# American Geotechnical, Inc.

April 2, 2021

Subject: **RESPONSE TO CITY OF LAGUNA NIGUEL GEOTECHNICAL REVIEW SHEET DATED FEBRUARY 15, 2021 AND NOTICE OF INCOMPLETENESS DATED FEBRUARY 23, 2021**  
Tentative Tract No. 17721  
The Cove at El Niguel  
30667 Crown Valley Parkway  
Laguna Niguel, California

References: **NOTICE OF INCOMPLETENESS FOR SITE DEVELOPMENT PERMIT SP 16-04 AND TENTATIVE TRACT MAP 17721 (30667 CROWN VALLEY PARKWAY – THE COVE AT EL NIGUEL)**  
By: Community Development Department, City of Laguna Niguel  
Dated: February 23, 2021

### 33348-08 The Cove at El Niguel Section DR-DR' Gross Static

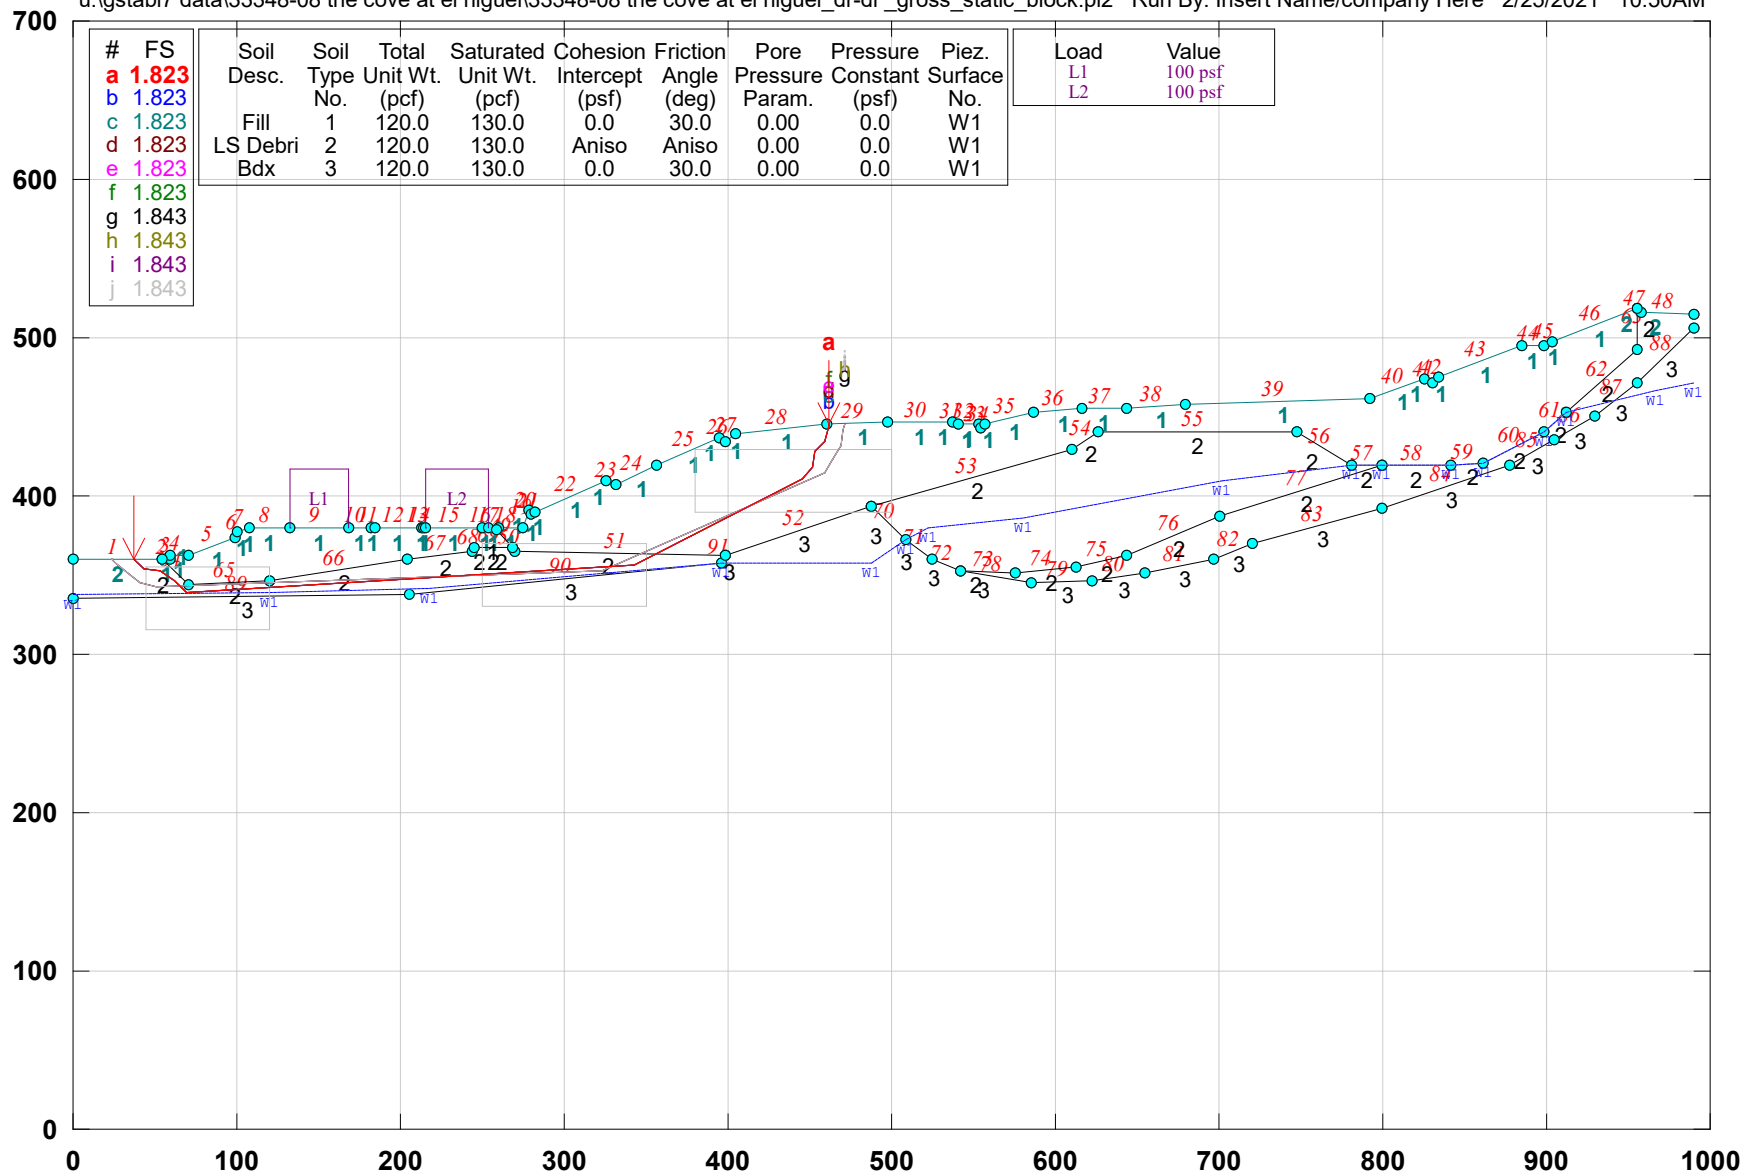
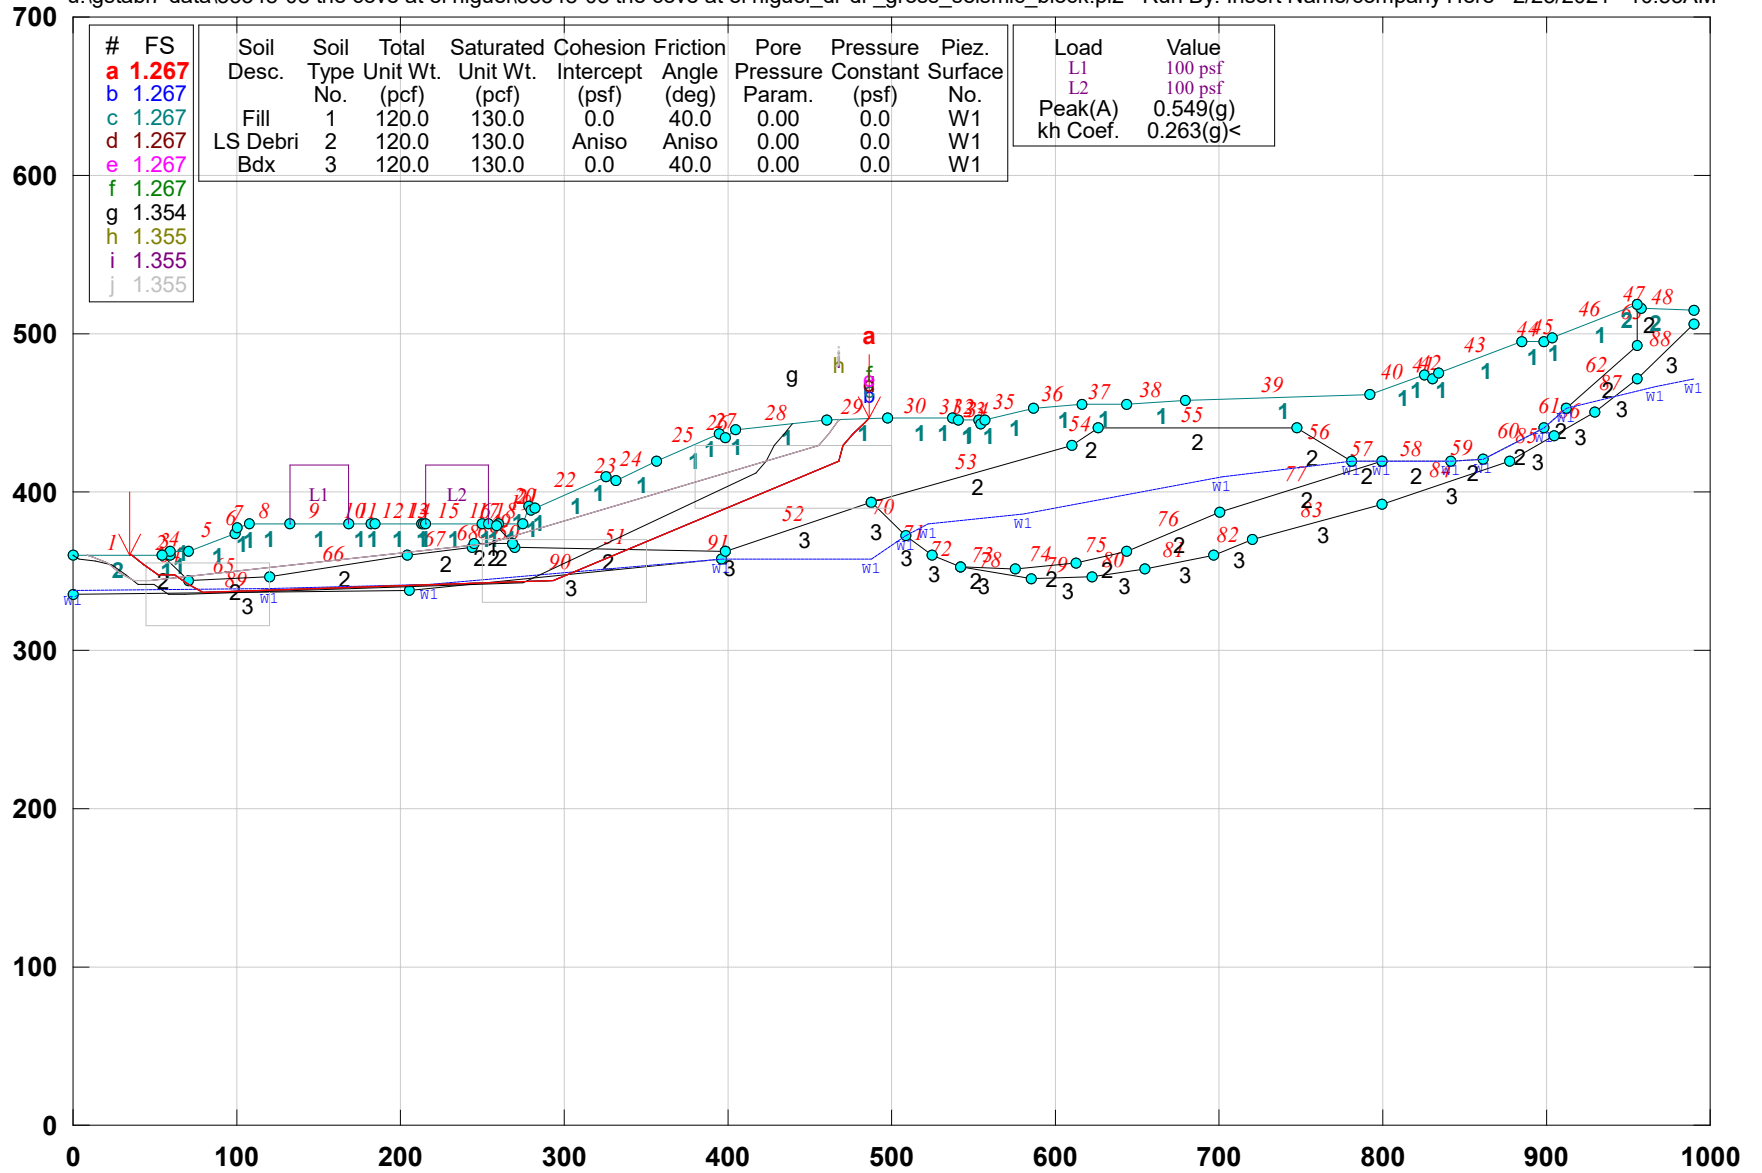
*Since the currently planned grading will now include the partial removal of the toe and keyway of the lower buttress, provide both static and seismic stability calculations for failure planes that extend from the new*

toe of the slope, below the MSE wall and through the slope above. Both circular and block type failure planes should be searched for Sections DR-DR' and J-J'.

We performed both static and seismic stability calculations for Section DR-DR' with a circular type failure plane search that extends from the new toe of the slope, below the MSE wall, and through the slope above. Results of our stability analyses were presented in our January 8, 2021 report. For static (long-term) and short-term (seismic) conditions, calculated factors-of-safety are 2.308 and 1.264, respectively.

Per the City's geotechnical review comments, we performed a supplemental stability analysis using block failure search extending from the new toe of the slope, below the MSE wall, and through the slope above. Results of our stability analysis using the block failure search for Section DR-DR' revealed that factors-of-safety under static (long-term) and pseudostatic/seismic (short-term) conditions are 1.823 and 1.267, respectively. Both values are exceeding the minimum required factors-of-safety of 1.5 and 1.1, respectively. Additionally, per the City's geotechnical review comments, we performed supplemental stability analyses for Section J-J' using both circular and block failure searches below the MSE wall and through the slope above. Results of our stability analyses revealed that the factors-of-safety under static (long-term) and pseudostatic/seismic (short-term) conditions are 2.203 and 1.601, respectively. Both values exceed the minimum required factors-of-safety of 1.5 and 1.1, respectively. Results of our supplemental stability analyses discussed above are included in **Appendix B**.
